ADDENDUM #3 TO BID #20-001

BID NUMBER: 20-001

PROCUREMENT FOR: Brick Chimney Road Improvement Project

GEORGETOWN COUNTY
 PLAN AND PROFILE SHEET
 BRICK CHIMNEY
 STA. 21+00.00 TO STA. 35+00.00
 SCALE 1" = 50' HOR. 1" = 5' VER. PLOT SIZE = 22" x 34"

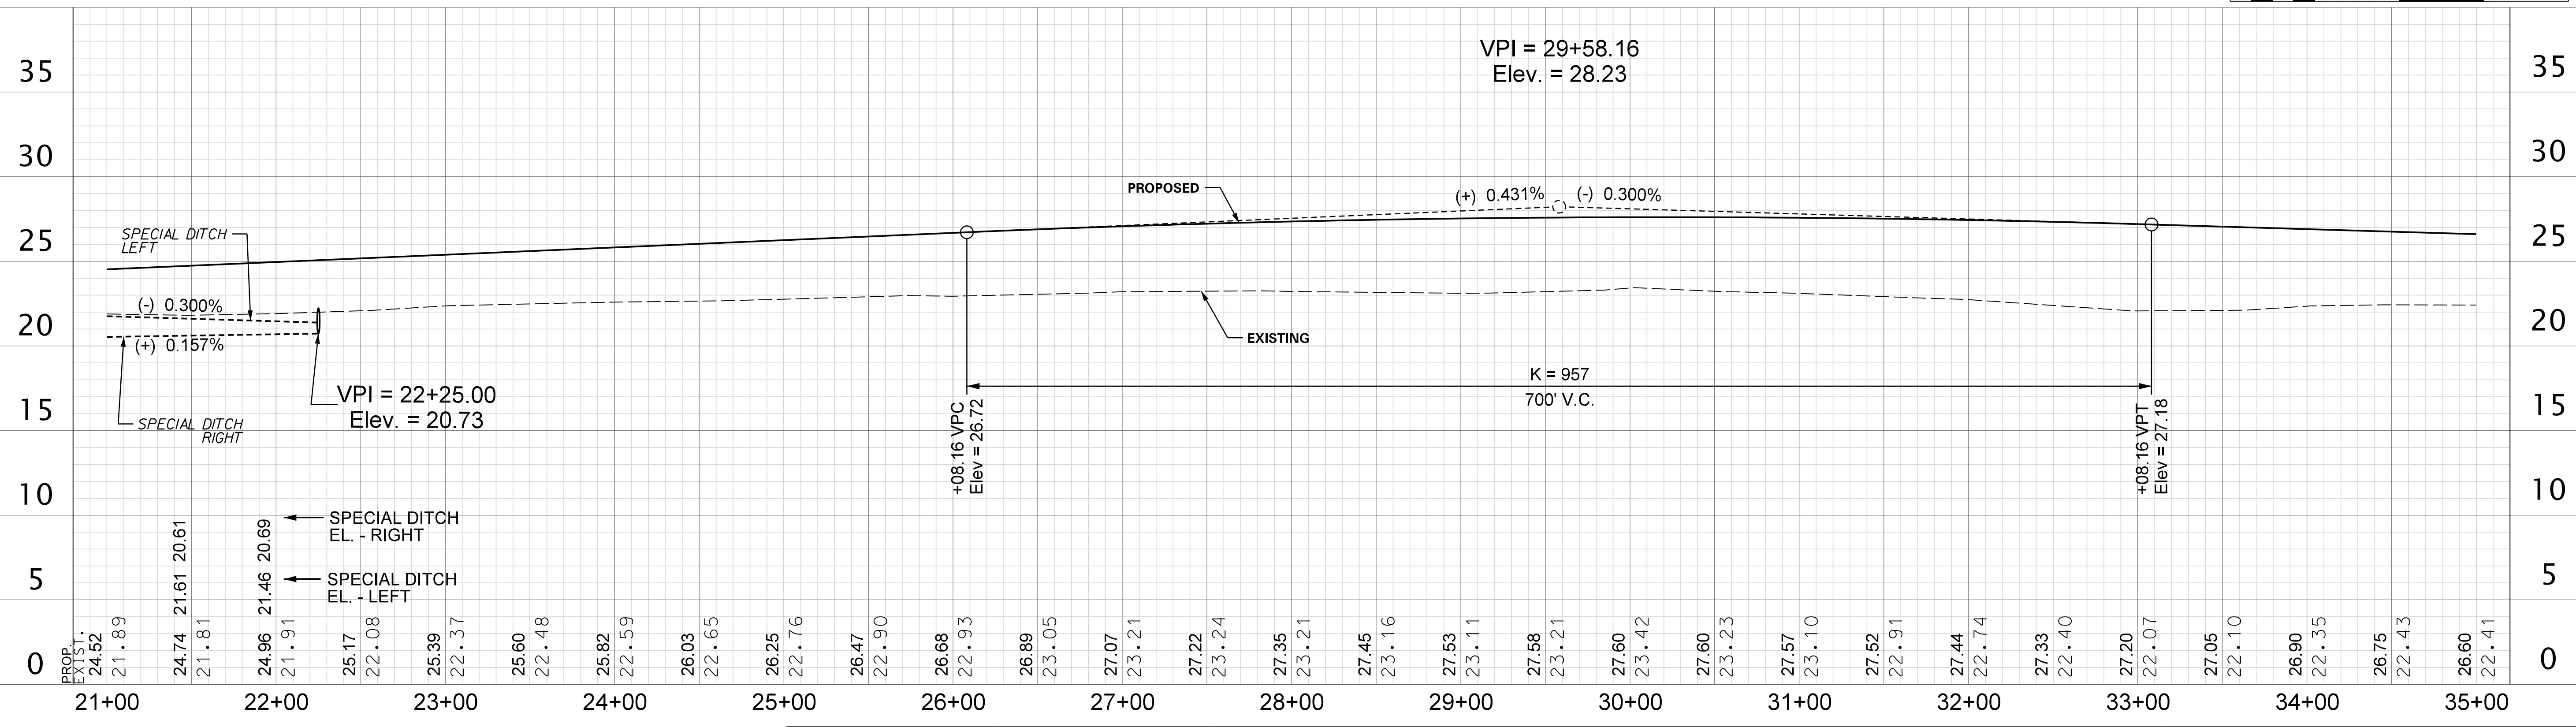
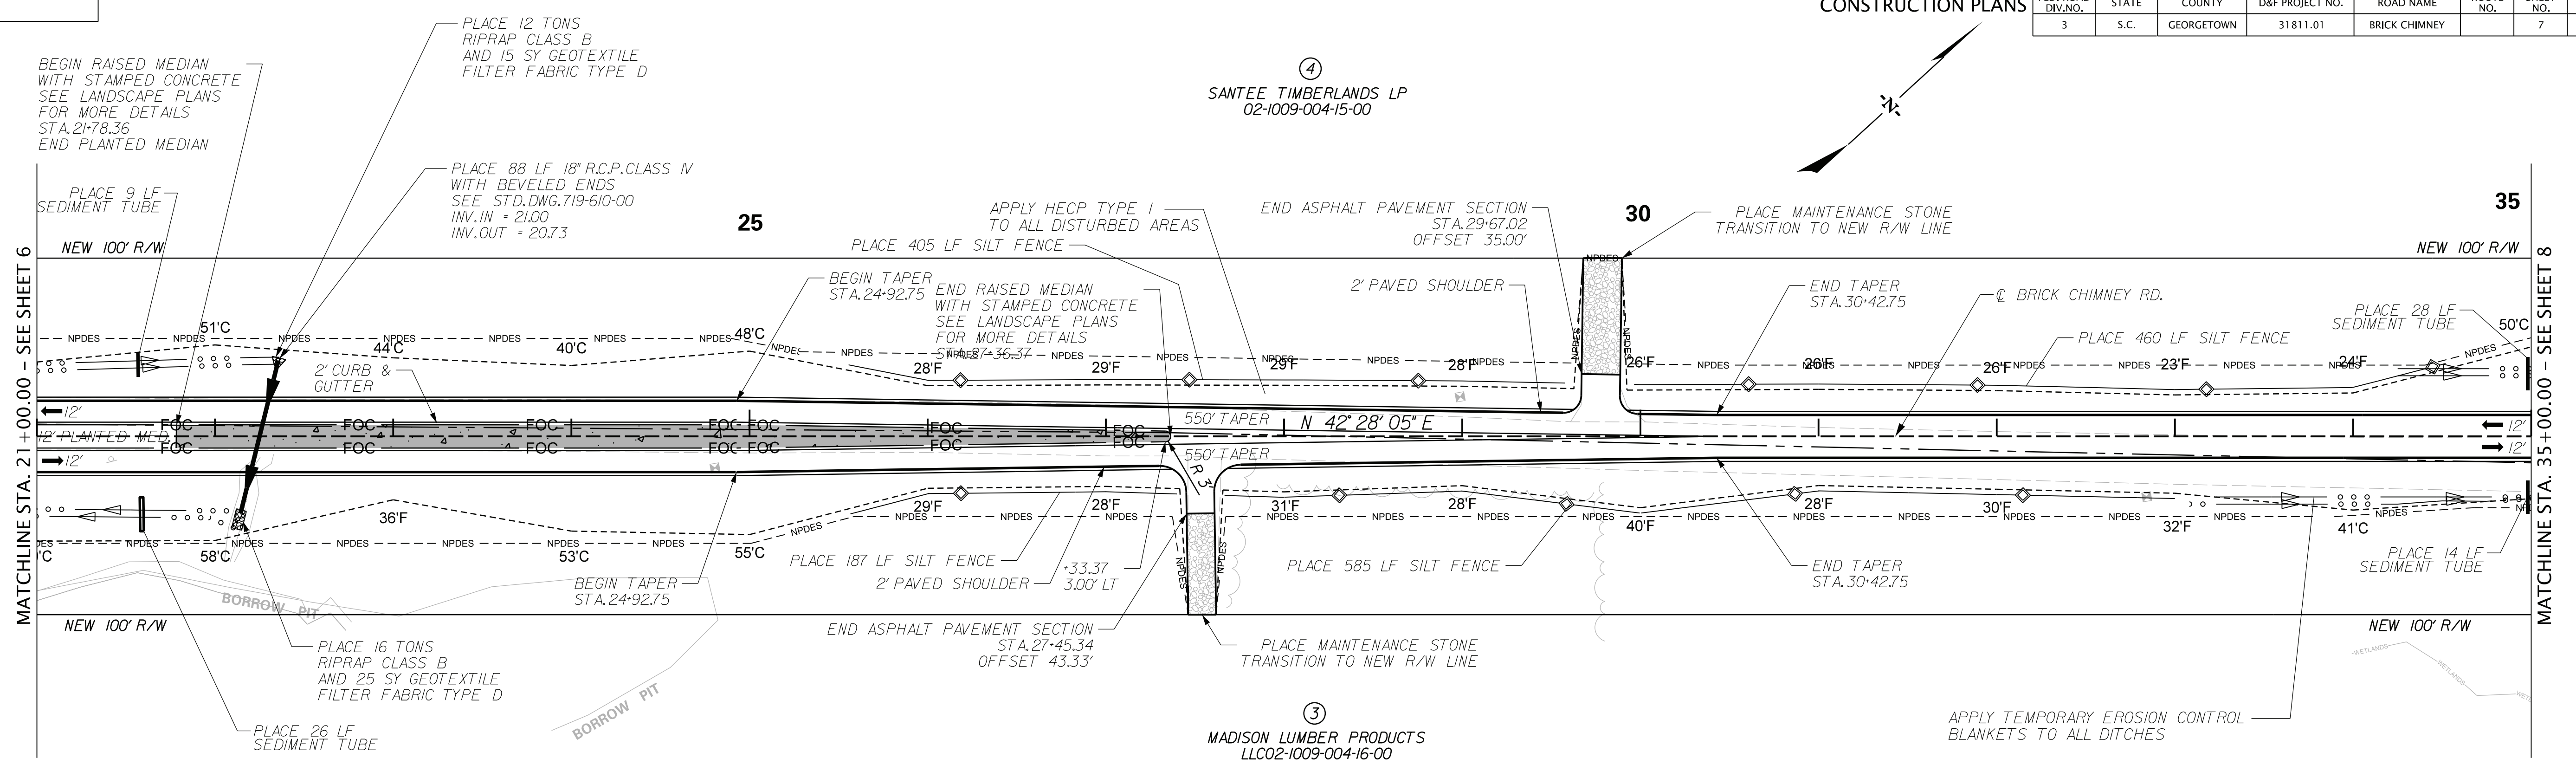
REVISION: NPDES lines have been updated on the attached three (3) plan sheets.
